**Staff Report to the Board of Architectural Review  
Design Review Major Modification  
Vietnamese Martyrs Church Expansion  
Prepared for the April 28, 2022 Meeting**

**FILE NUMBERS:** L21-0104 Design Review Modification

**APPLICANT:** Sean Hill of Broderick Architects on behalf of Vietnamese Martyrs Parish

**REQUEST:** Request for approval of a Design Review Major Modification (to the L18-0026 decision) to reduce the proposed building footprint from 67,500 SF to 45,290 SF, with accompanied façade changes to the north, east and west building elevations.

Figure 3. Streetscape along Sperry Drive

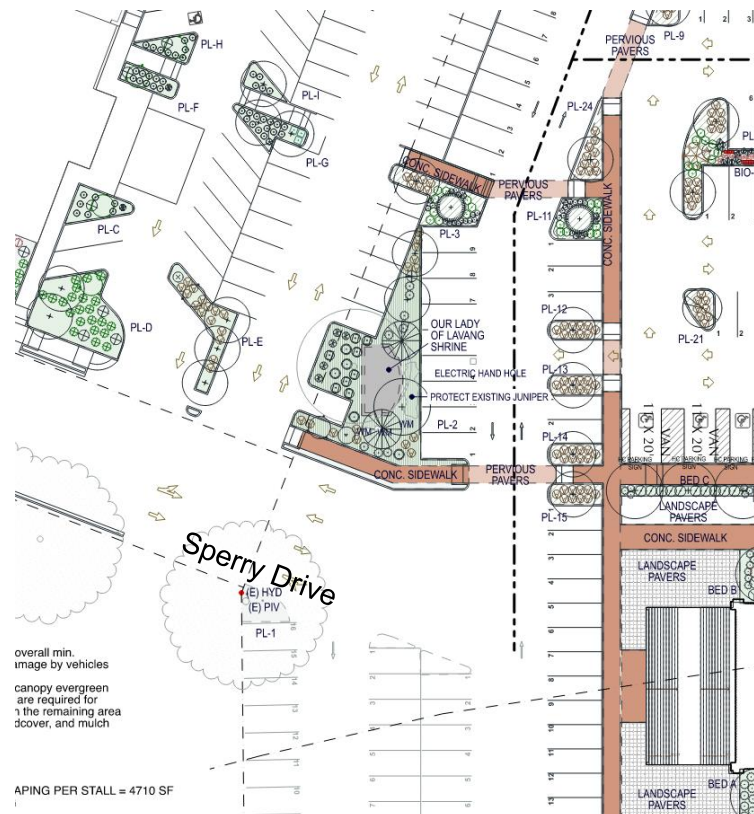
The project includes additional landscape square footage and plantings throughout the new and modified parking areas to meet both streetscape and pedestrian site design criteria. Bioretention areas and shade trees have been added to soften the visual appearance and break up the large, paved areas. Pedestrian pathways have been added throughout to connect the new and existing parking areas to the front and side church

entrances. The modified project provides a more robust overall landscape design, particularly along the entry drive aisle from Sperry Drive to create a desirable streetscape transition.

As the project now includes the demolition of the northeast corner of the existing structure, the building footprint has been significantly decreased from 67,500 SF to 45,290 SF, which reduces the building scale particularly along the Sperry Drive frontage.

Figure 4. Widened Fire Access Lane

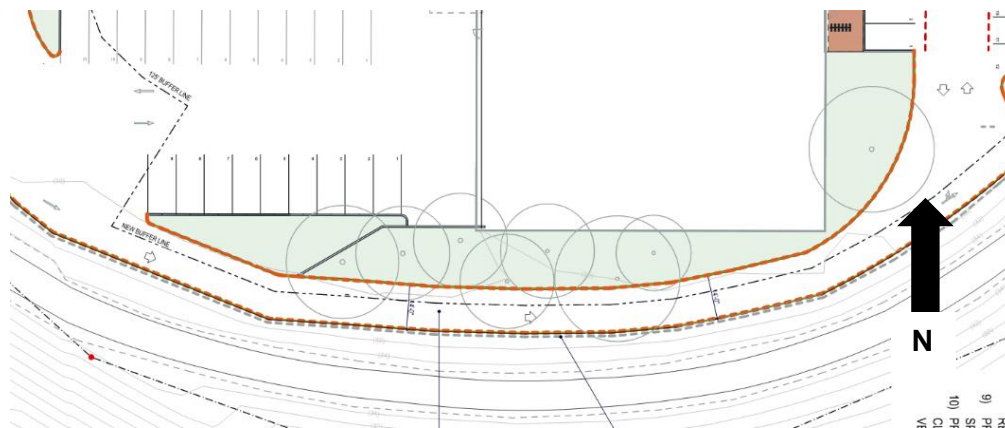
In order to meet Fire safety access requirements, the access road has been widened to 14' along the southern portion of the site, adjacent to the shoreline. To accommodate the widened access road, the width of the perimeter landscaping in this area has been reduced and 3 additional trees are proposed for removal. To account for the additional tree removals in the shoreline overlay jurisdiction, as a condition of approval, the applicant shall obtain an amendment to the previously approved Shoreline Tree Permit.

2. Prior to approval of Development Permit (D21-0032), the applicant shall obtain approval of an amendment to Shoreline Permit L18-0025 for removal of 3 additional trees within the shoreline jurisdiction.

Figure 5. New Parking Area

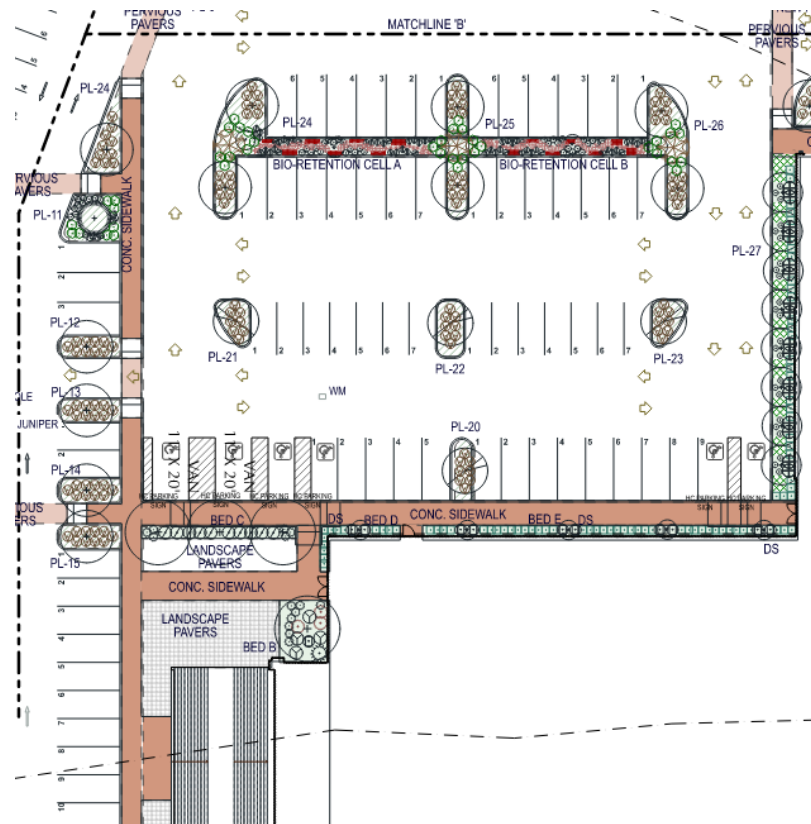
Throughout the new parking area, landscaped islands are positioned no more than 10 stalls apart. These landscaped areas are planted with deciduous trees, shrubs and groundcover. The modified project also proposes 3 new bioretention areas distributed throughout the eastern parking area. The modified project includes an additional 2,892 SF of landscape area to supplement the 63 new parking stalls placed where the existing northeastern corner of the church will be demolished.

Figure 10. West Elevations

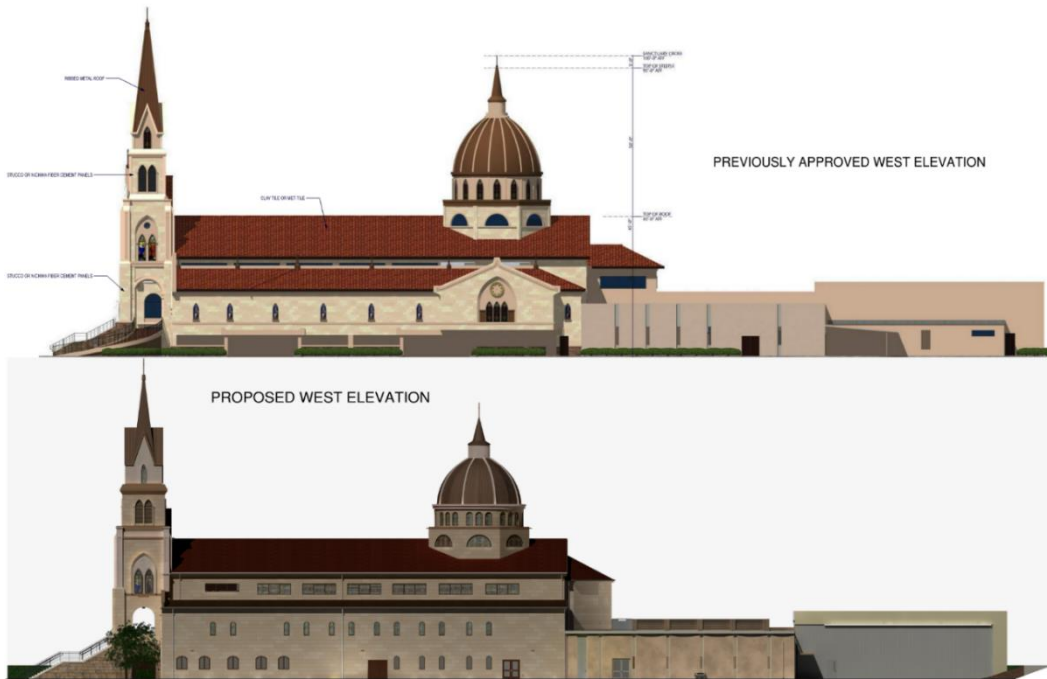
Plans for the modification initially proposed a more simplified design with blank wall areas along the east and west elevations. Planning staff has worked with the applicant to update the initially proposed modified building elevations, enhancing the level of architectural detail and visual interest. The facades avoid a monotony of design by providing fenestration in the form of additional windows, a central pediment wall, vegetative screening, and a variation in roofline. As a result, staff feels that the applicant has demonstrated an effort to reintroduce a variety of form and detail consistent with the anticipated life of the structure.

Figure 12. Rooftop Screening

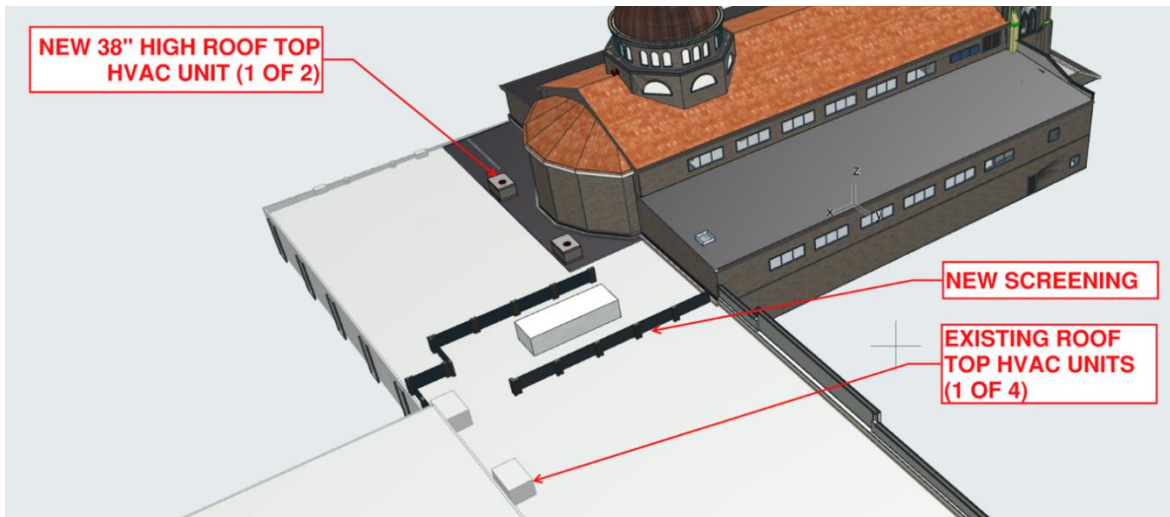
A new 38" tall HVAC unit has been added to the existing church's southern rooftop, which will be appropriately screened with finished steel screening panels and painted to match the existing structure. Existing rooftop mechanical equipment will be similarly screened with metal screening panels.
